# Staff Report

**Project Name:** COA for a Roof Addition and Exterior Modifications

**Case Number:** COA25-0004

**Location:** 2450 W. Main Street

Figure 3: Fly tower screen elevation highlighting design references

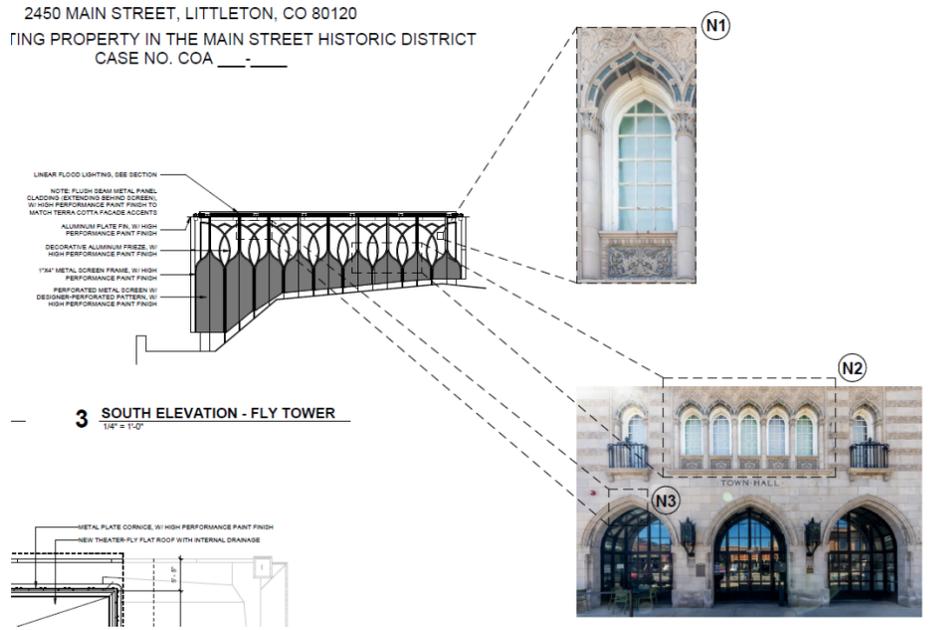
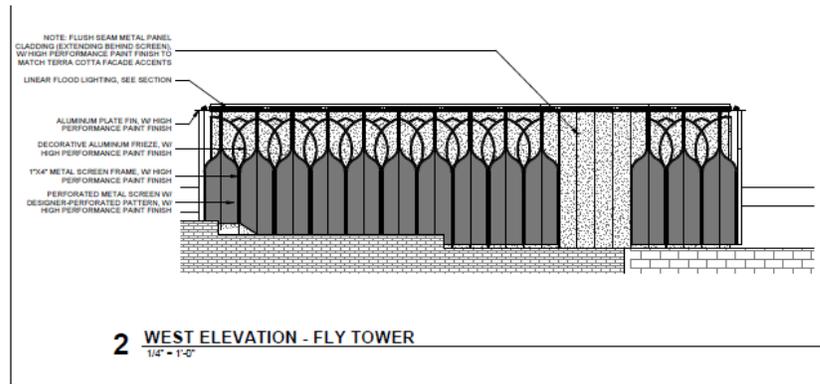
Changes to the roof include an addition to accommodate a theater fly system, replacement of the roof membrane, and repairs to damaged roof structure. The theater fly system will be enclosed with a detailed, aluminum metal screen. The material was chosen due to its light weight. The addition has a footprint of approximately 23ft by 38ft and will be set back from the front façade 26ft. The addition will be about 5ft taller than the parapet and increase the building height to 42ft, which is 3ft less than the maximum allowed. The design of the structure incorporates decorative elements from the front façade; primarily the pointed arches on the first floor and the grouping of windows on the second floor.

(i) *The rooftop addition will be 5ft taller than the main building and is of a size and location to minimize its visual impact. The addition will be partially visible within the district but provides visual interest and references design elements within the historic buildings. When looking straight on at the building, site line drawings show that the addition will not be visible, which preserves the ability to experience the building without the addition.*

*Figure 5: Renderings showing visibility of the fly tower*

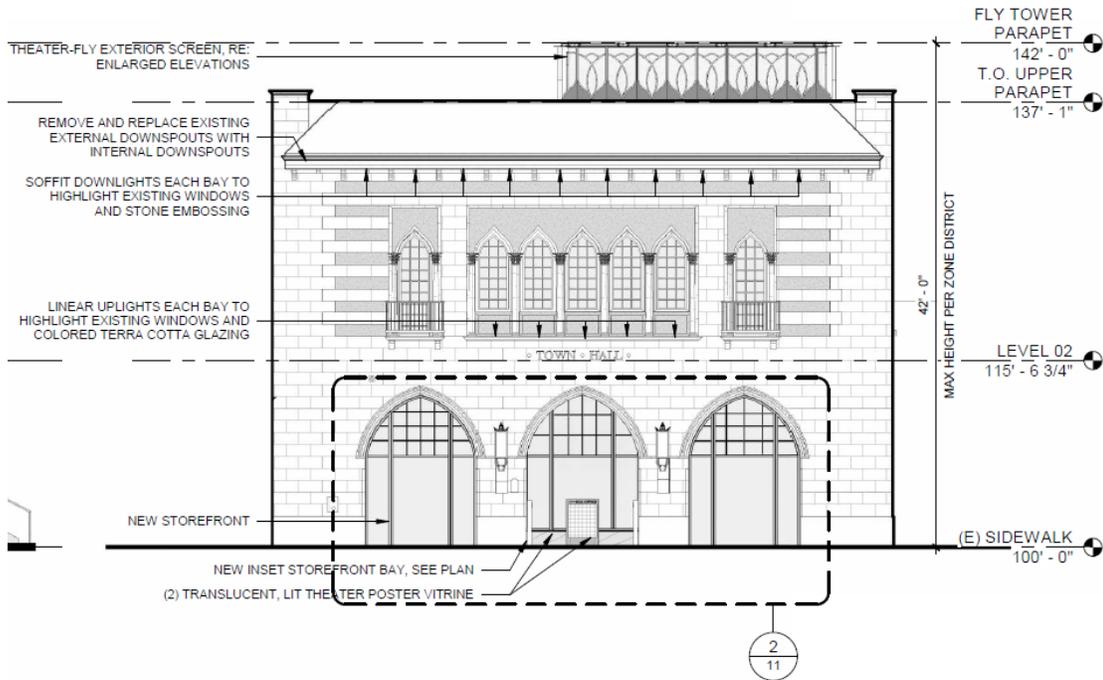
The proposed addition will be visible from within the district. The screen will not be visible from directly across Main Street but is visible from the east and west of the building while walking along Main Street. Site line drawings taken from adjacent streets indicate when looking straight on at the building the additions will not be visible, but the renderings provided do indicate the screen will be visible from certain locations.

Figure 6: North Elevation

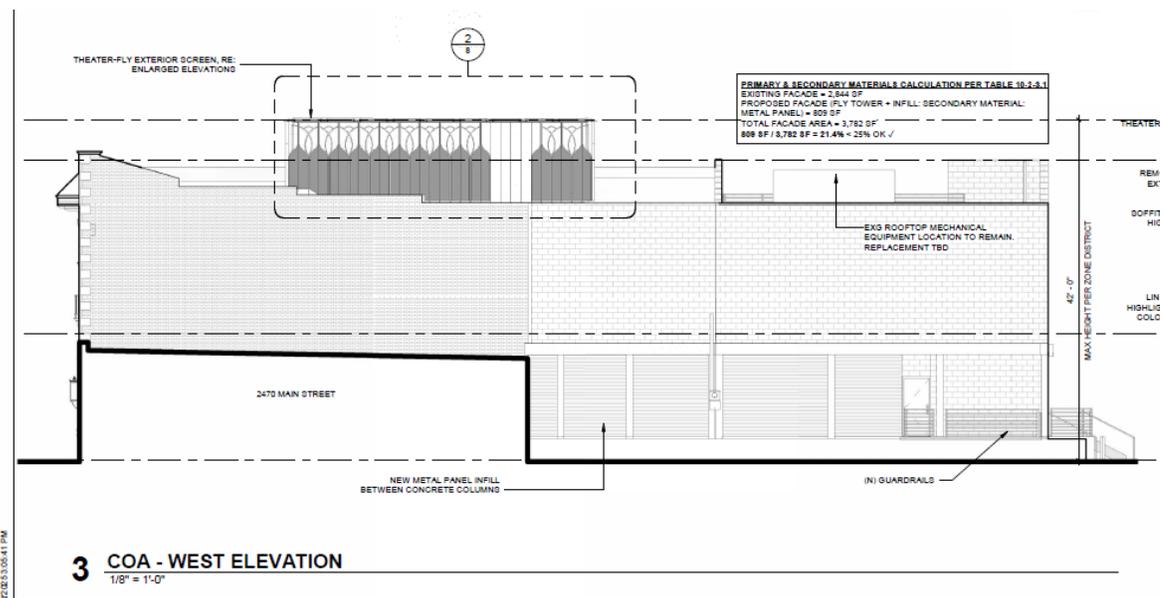
Modifications to the front façade are primarily focused on restoring features, but does include changes to incorporate new features to the entryways on the first floor. To better accommodate the building’s use as a theater, the applicant is proposing to recess the central entry to a depth that mimics the original design. The ceiling of the entry will mimic the pointed arch and be painted to mimic the teal terracotta on the second floor windows. The entrance doors will be placed within the right and left sides of this central arch and will be perpendicular to Main Street. The windows parallel to Main Street are more storefront in design and incorporate the existing grid pattern in upper portion of each arch. The lower portion of the windows are predominantly unobstructed to allow for promotion of shows. The storefronts installed in the east and west arches will be less recessed, sitting just behind the masonry. The existing wrought iron lanterns will be maintained and gas hookups will be reestablished to bring them back to functionality. The downspouts on the building will be removed and internal drains will be installed to match the original design of the building. The windows on the second floor of the building are currently blocked off on the interior of the building. The applicant is proposing to unblock the windows and will repair rather than replace them. The addition of inset lights to the underside of the roof overhang is also proposed.

Figure 7: West elevation

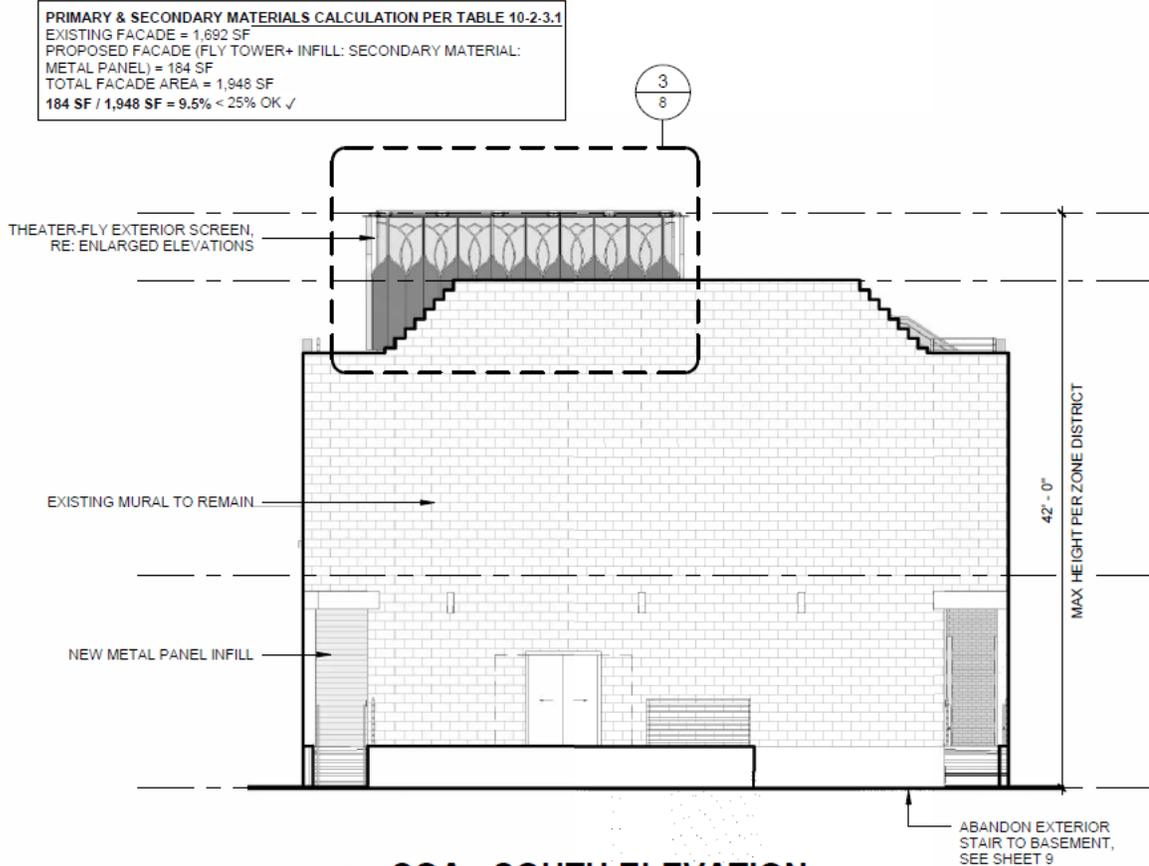
There are proposed modifications to the west side of the building but are concentrated on a later addition to the building. The existing ramp and walkway will be enclosed with metal paneling to allow for greater use of the area as an interior space. To maximize the interior space, metal panels are proposed due to the thin profile of the material. The existing ramp will be removed and replaced with a flat walkway and stairs. A new guardrail of a similar appearance will be installed along the walkway.

Figure 9: East elevation

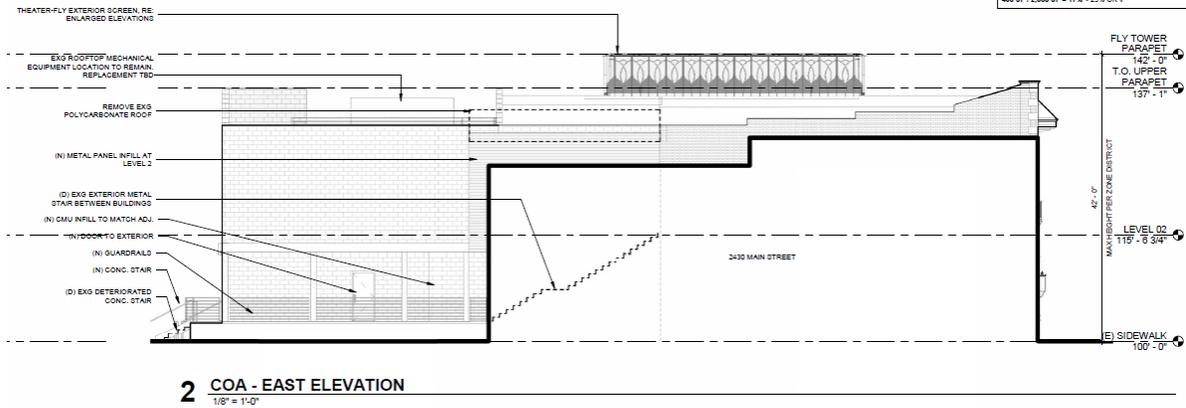
The modifications to the east elevation are concentrated on the second floor of the building, with minor changes to the first floor. The applicant is proposing to enclose and existing, open-air walkway with fiberglass roof covering. The roof will be removed, and the space will be enclosed with metal paneling. An existing door will be enclosed with a new door installed in the same wall in a new direction. The existing guardrails and concrete steps to this area will be replaced with similar materials and appearance.
